Receiver RF Amplifier Protection

This modification provides better protection for the RF amplifier FETs from spikes that may appear at the input for those FT-102s having serial numbers below XX040000. It has been incorporated in all transceivers from Lot 4.

Solder side

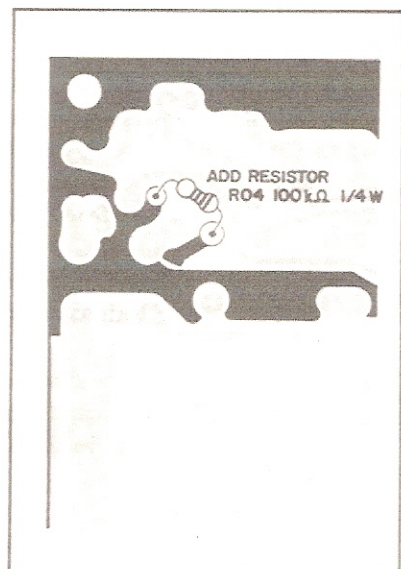
1. Remove the covers and expose the solder side of the RF Unit as described on page 8.
2. Referring to the drawings below, locate resistor R04, and carefully remove the indicated end of this resistor. Reconnect it as shown.
3. Replace the shield cover and AF Unit, the AM/FM Unit, and the covers and associated screws.
